# TDECQ Calculation

IEEE 802.3dj Ad Hoc

# Review of Cl 180.9.6.4

Figure 121-5—Illustration of the TDECQ measurement

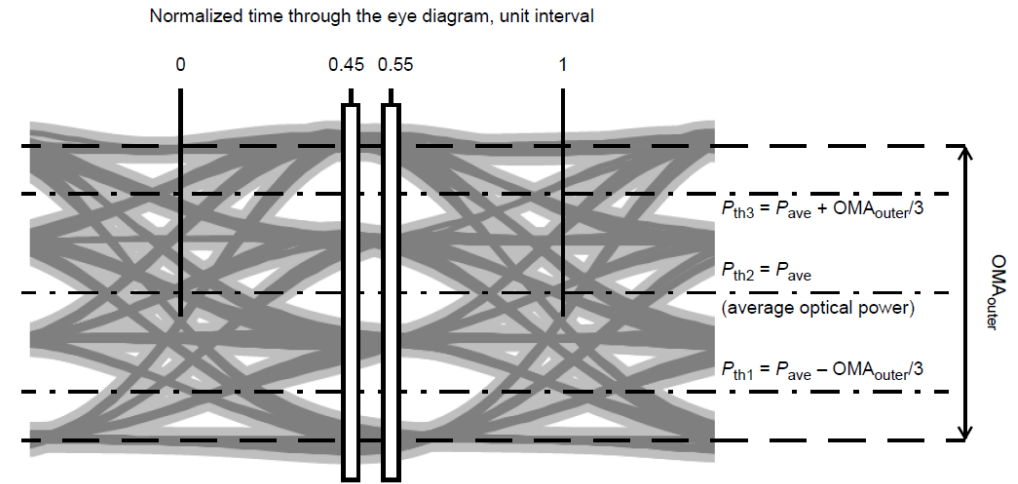
- Clause 180.9.6.4 does not compute symbol error rate as described on the previous slides
  - Instead, for each threshold, it calculates a “Cumulative Distribution Function”

- It then computes a weighted sum of the  $\text{CDF}(y_0, P_{\text{th}}(i))$  values over all  $y_0$ , where each value is weighted by the probability that the Gaussian noise is  $P_{\text{th}}(i) - y_0$
- It does this for each of three thresholds, then sums those three probabilities for the final probability of symbol error

- Since the transmitted sequence is known, we should compute the symbol error rate for added noise using the transmitted value and not just assume that it was received in the correct zone.
- This can be approximated using histograms for  $y$  and the appropriate ERFC or Q function.
  - Closed form expressions for Q that give very good approximations can be used

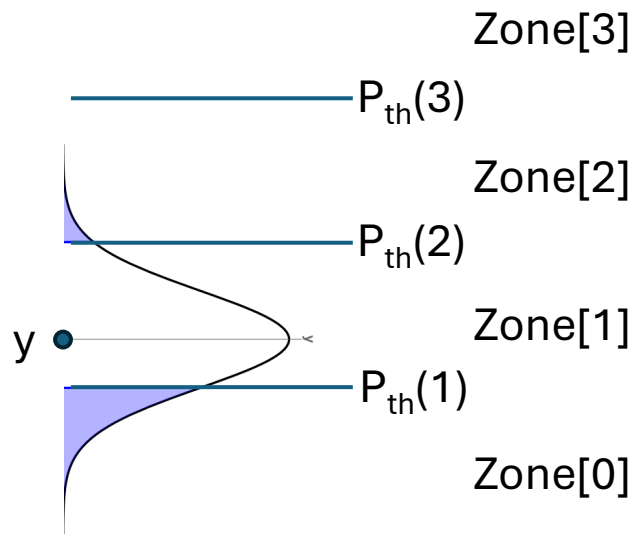
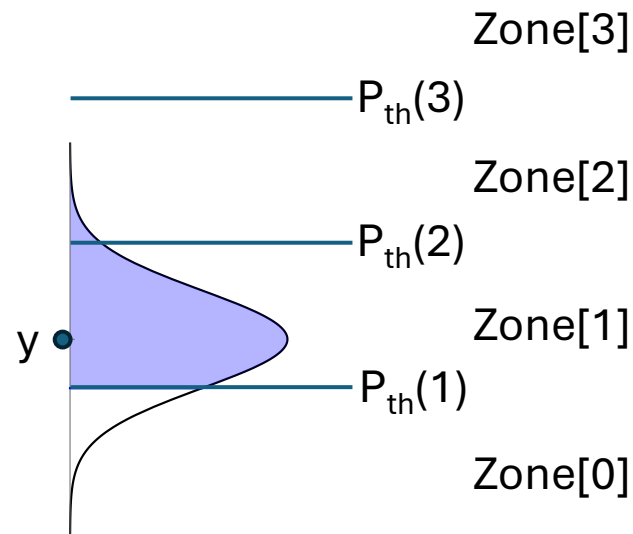
For  $x = 1$  and  $y$  received as shown, probability of error is shaded integral

For  $x = 0$  and  $y$  received as shown, probability of error is shaded integral

When  $y$  starts in the incorrect zone, a symbol error is made if the noise does not put  $z$  back in the correct zone.

CDF and Gaussian Function for Threshold 1

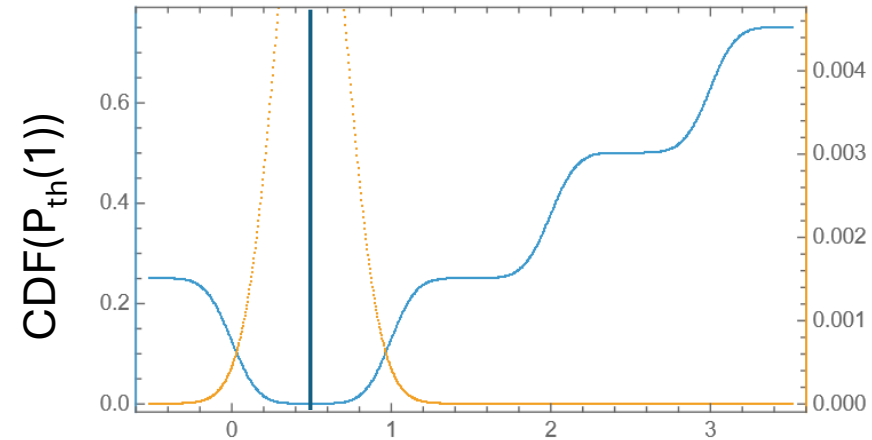
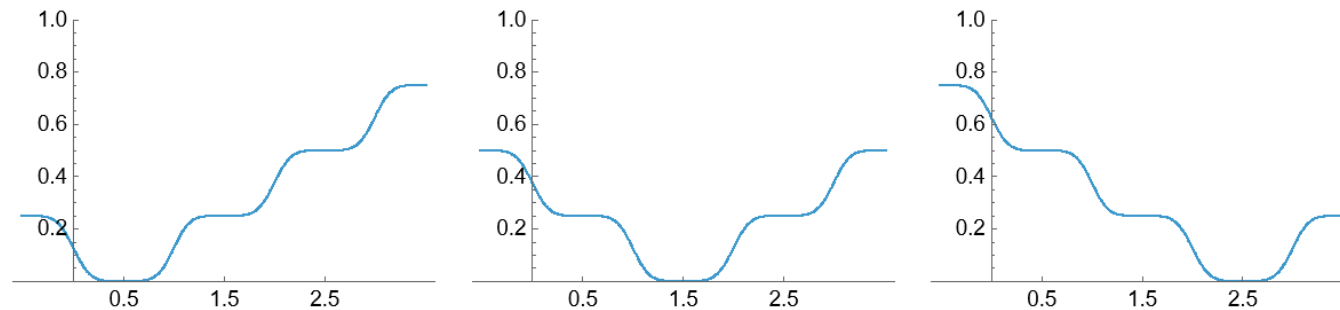
- The current SER estimation method:
  - Double (or triple) counts some errors by counting the crossing of two thresholds as two symbol errors
  - Does not account for the tail of the Gaussian probability for the extreme  $y$  values, so underestimates that part
  - Underestimates symbol error if  $y$  is in the wrong zone before adding noise
- These issues can be fixed by using the Q-function and using the known transmitted sequence.
- The magnitude of the error has not (yet) been demonstrated.
- Question: Is this worth fixing?
